100GBASE-SR4: Effects of Instrument Noise

Comments i-25, i-26, i-27 & i-28

John Petrilla: Avago Technologies

July 2014

Ref Rx Sensitivity & Observed Tx 5E-5 Contours

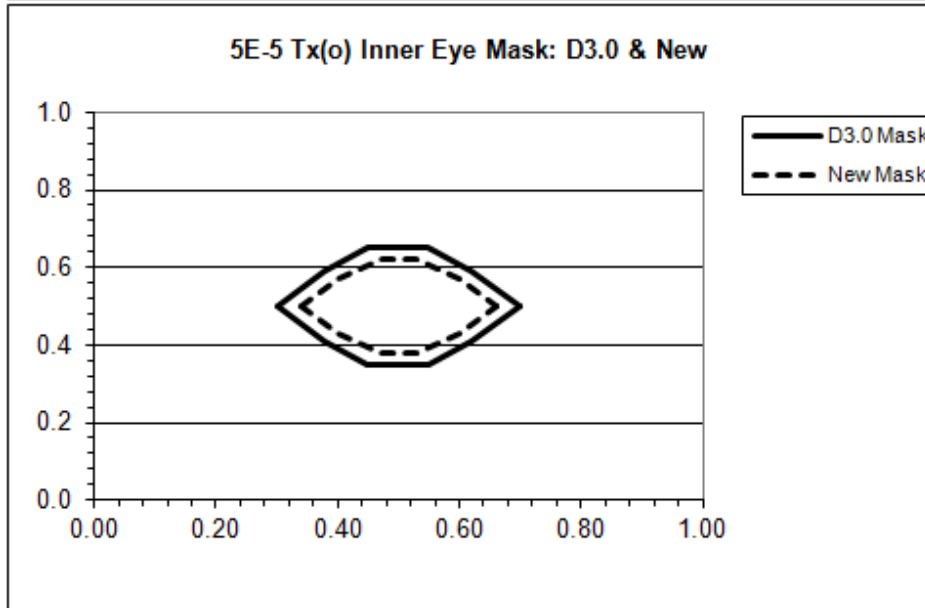
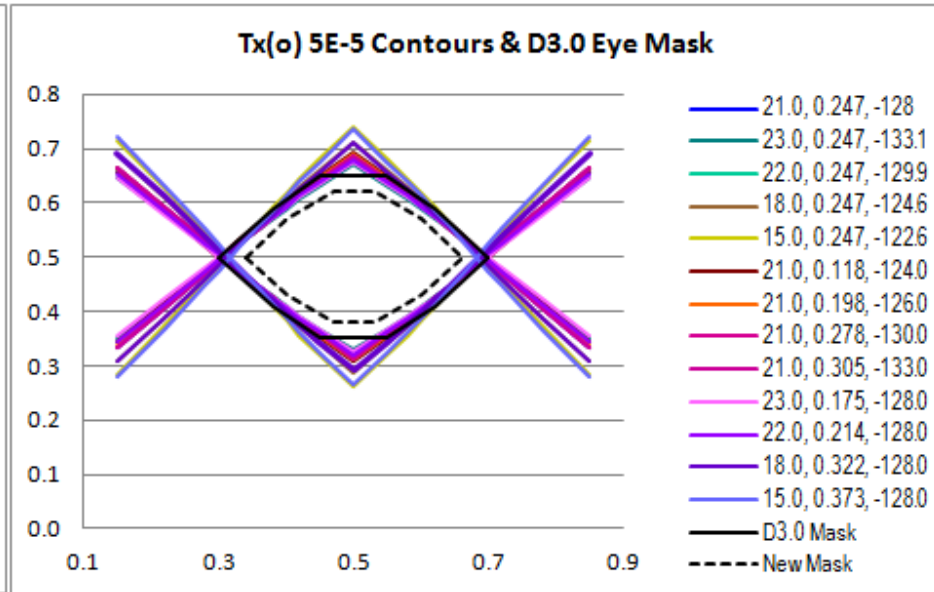
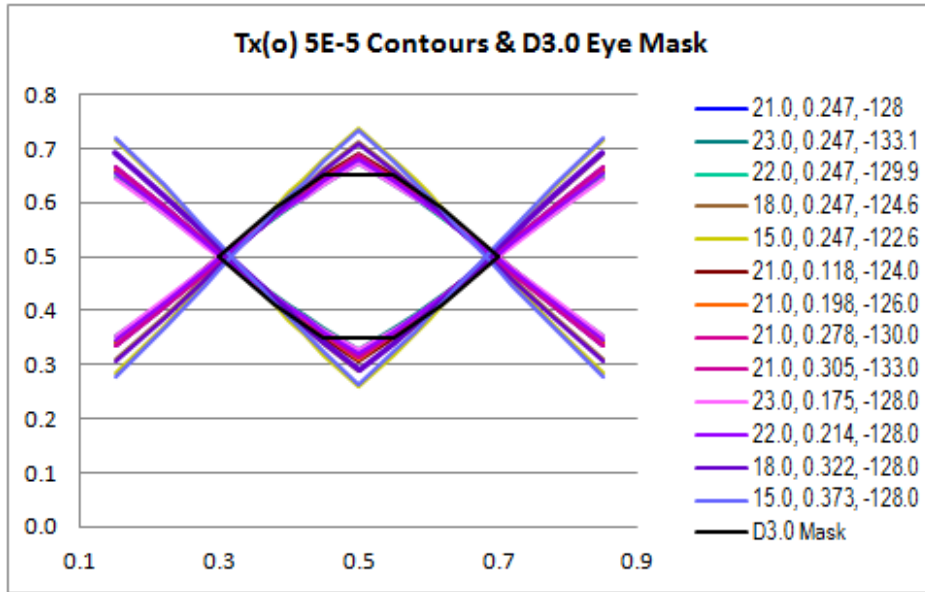
Comments i-25 & i-27

- The chart on the left shows the expected observed Tx TP2 5E-5 contours for a set of worst case transmitters at the time of the March 2014 meeting with the inner eye mask that is defined in Draft 3.0. These contours were based on an expected oscilloscope dark RMS input noise of 4.5 μ W for a 19.3 GHz optical plug-in. Since then the expectation for dark RMS input noise has changed to 17 μ W. This results in shift from an expected RJ of \sim 0.24 UI in the mask test to an expected RJ of \sim 0.36 UI.

- The chart on the right shows expected observed Tx TP2 5E-5 contours for a set of worst case transmitters based on a scope with an expected dark RMS input noise of 17 μ W for a 19.3 GHz optical plug-in. None of the worst case contours will pass the currently defined eye mask.

- It may be possible to keep the same mask coordinates by reducing the hit ratio from 5E-5 to 1.5E-3 (reduces RJ from 0.36 UI at 5E-5 to 0.24 UI at 1.5E-3).

- A new 5E-5 hit ratio mask is proposed on the following page.

Comments i-25 & i-27

- The chart on the upper left repeats a chart from the prior page.
- The charts on the upper right and lower left show a newly proposed Tx eye mask that accounts for the currently expected oscilloscope input noise.
- Eye mask coordinates X1, X2, X3, Y1, Y2, Y3

Draft 3.0: 0.30, 0.38, 0.45, 0.35, 0.41

New: 0.34, 0.40, 0.47, 0.38, 0.43

TP3o 5E-5 Contours

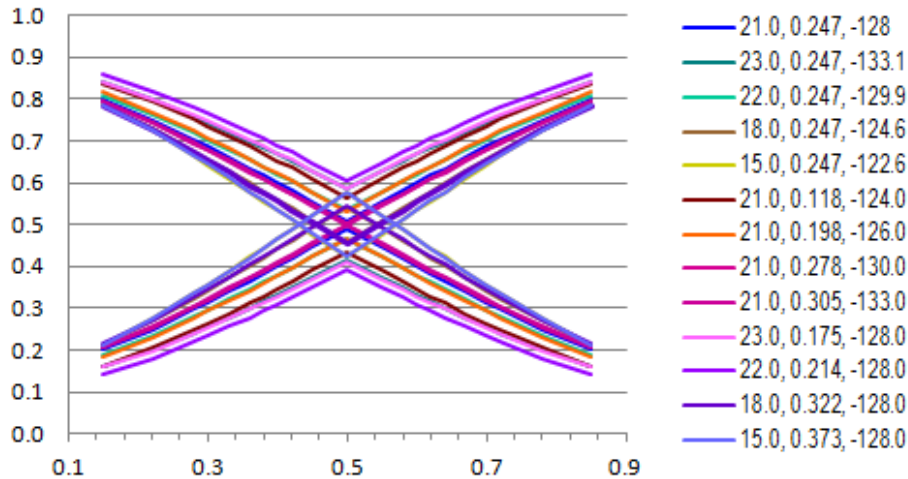
Comments i-26 & i-28

- The upper-left chart shows expected observed 5E-5 contours from a set of worst case transmitters based on a scope with an expected dark RMS input noise of 17 uW for a 19.3 GHz optical plug-in. Here OMA at TP3 is min Tx OMA at max TxVEC (or TDP) of -3.0 dBm less insertion loss of 1.86 dB and RxS is -8.79 dBm (= 10Log(2Q x 0.017mW) yielding a signal 3.9 dB above sensitivity. There is very little to no eye opening.

J2 & J4 vs OMA(TP3) - RxS

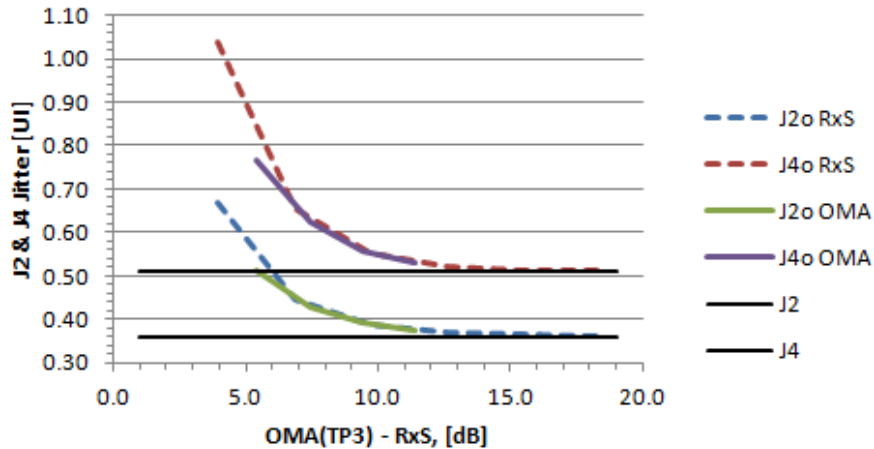
- The lower-left chart shows expected observed J2o and J4o jitter for the worst case Tx labeled (21.0, 0.247, -128) over a range of signal levels above sensitivity. The graphs labeled Jn RxS were created by changing Rx sensitivity & the charts labeled Jn OMA were created by changing Tx OMA after deleting the 1.5 dB connector loss. The graphs labeled J2 & J4 do not include observation impairments.

- A 10 dB signal level above test equipment sensitivity may be reasonable to expect when calibrating the stressed receiver input signal for J2 and J4, producing only minor impairments that can be included in the stressed receiver sensitivity (SRS) J2 and J4 conditions. Here the expected observed values are:

$$J2 = 0.39 \text{ UI}$$

$$J4 = 0.55 \text{ UI}$$

D3.0 TP3o 5E-5 SRS Inner Eye Mask

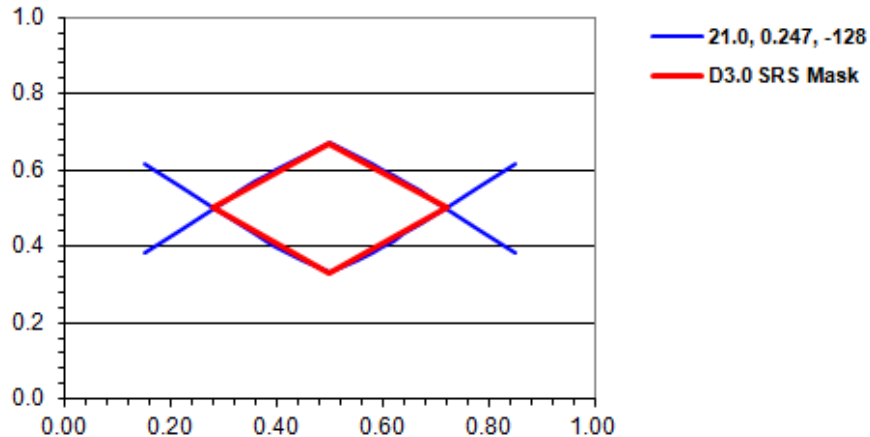
- The chart shows expected observed 5E-5 contours for the worst case Tx labeled (21.0, 0.247, -128) based on a scope with an expected dark RMS input noise of 17 uW for a 19.3 GHz optical plug-in and a signal ~ 10 dB above the scope sensitivity. The resultant eye appears suitable for calibration of stressed receiver sensitivity conditions.

- The SRS eye mask defined in D3.0 is included. **No adjustment appears needed for the eye mask coordinates or VECF.**
